REQUEST

Current Zoning: R-3 (single family residential)
Proposed Zoning: R-12MF(CD) (multi-family residential, conditional)

Approximately 30.73 acres located on the north side of South Tryon Street, south of Erwin Road, east of Choate Circle.

STAFF RECOMMENDATION

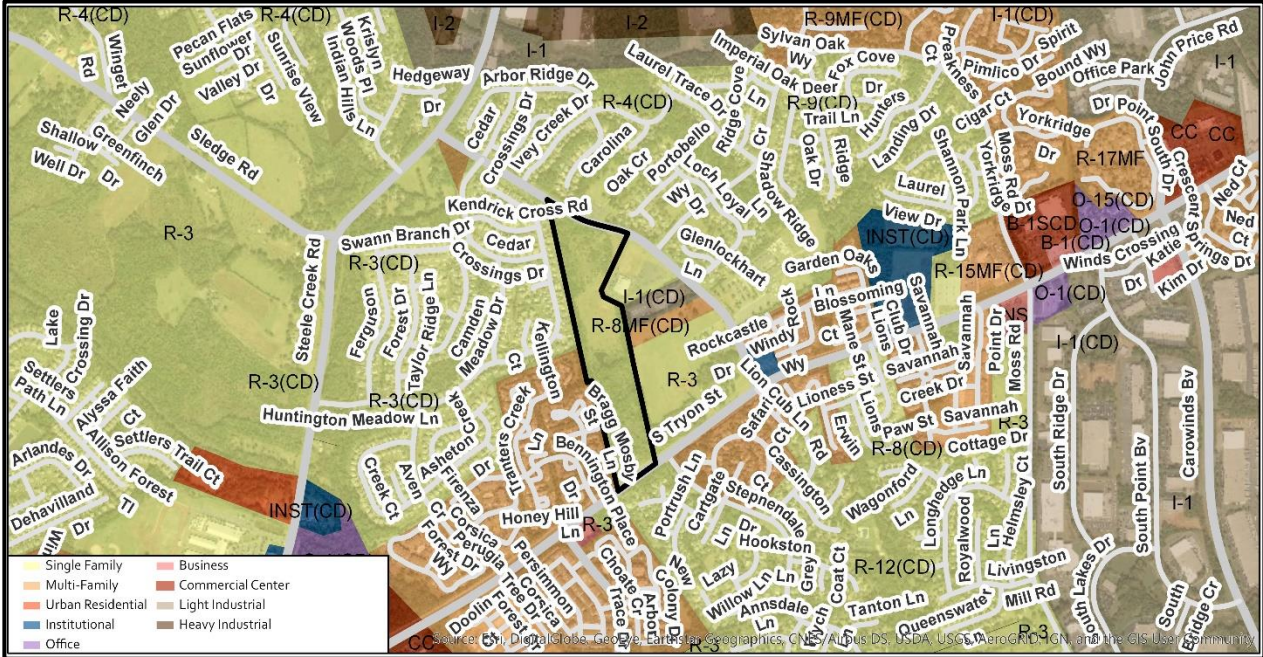
1. Reduce density of proposal to better conform to the recommendations of the area plan.
2. Consider reducing building masses of buildings 6, 7, & 8 to better transition to adjacent single family uses.
3. Increase fence height from 5 feet to 6 feet along adjacent single family property lines, and clarify fence type to ensure it provides adequate screening.

4. Under Site Data remove "Min. Building Separation: 10' Per Ordinance" from the site plan.
5. Label setbacks along Erwin Road and Public Road A.
6. Confirm if the area adjacent to proposed Building 3 is a dumpster enclosure/refuse area. If so, label on the site plan.
7. Remove Monument Sign label and proposed location from the site plan.
8. Petitioner proposes a 50-foot Class C buffer along the western property line. Open Space and Amenities Note VII.3 proposes a "minimum 37.5-foot Class C buffer" in this location. Petitioner should clarify intent to have ability to reduce buffer by 25% with wall or fence per ordinance and modify labelling and development note to reflect consistency.
